To: Auburn Planning Board  
From: Katherine Cook, Planning Coordinator  
Re: PAL Center Development Review Report  
Date: January 9, 2024

**I. Proposal: Public Hearing/ Site Plan Review:** The City of Auburn is applying to replace the existing Police Activities League (PAL) Center located at 24 Chestnut Street, City Assessor's Parcel I.D. 250-334. The proposal includes the demolition of the existing PAL Center (approximately 4,896 sq. ft.) to replace it with a 14,651 sq. ft. single-story facility with a basketball court, teen room, multipurpose, meeting, and storage rooms, bathrooms and showers, and a commercial kitchen. Site work will also include utility improvements, transportation, and pedestrian improvements along Chestnut St. to Winter St. and Walnut St., a playground, parking lot, and community gardens. This proposal is pursuant to Chapter 60, Article XVI, Division 2 – Site Plan Review and Division 14 – Form-Based Code.

## Sec. 60-549.1. Building placement and configuration T-4.2.

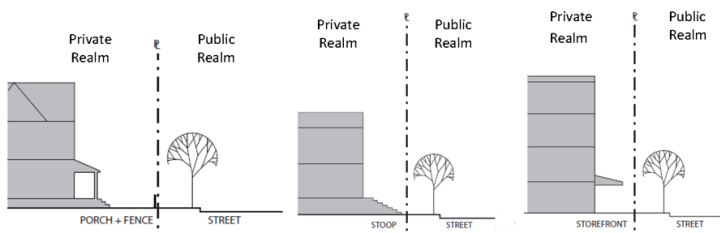
PRINCIPAL BUILDING PLACEMENT:			
Front Setback, Principal:	5 ft. Min/, 15 ft. Max	(A)	7 feet - Meets requirement in both possible front facades.
(Corner Lot) Front Setback, Secondary:	5 ft. Min., 15 ft. Max.	(B)	6 feet - Meets requirement.
Side Setback:	5 ft. Min.	(C)	Meets requirement
Rear Setback:	10 ft. Min.	(D)	Meets requirement
Building Lot Coverage:	70% Max.		4.9% - Meets requirement
Useable Open Space:	10% Min.		Meets requirement.
Frontage Build-Out:	60% Min (along Front Setback, Primary)		66%, - Meets requirement along parking area.
Lot Width:	24 ft. Min, 120 ft. Max.		N/A - Preexisting lot.
PRINCIPAL BUILDING CONFIGURATION:			
Building Width:	14 ft. Min., 110 ft. Max.	(E)	165 feet- Does not meet requirement if parking is along the frontage. See Waiver Request #1. If former Chestnut Street is considered as the frontage, then the building does meet the requirement.
Building Height Minimum:	1 Story Min.	(F)	1 story, meets requirement

Building Height Maximum:	3 Story Max.	(F) (excluding attic story)	1 story, meets requirement
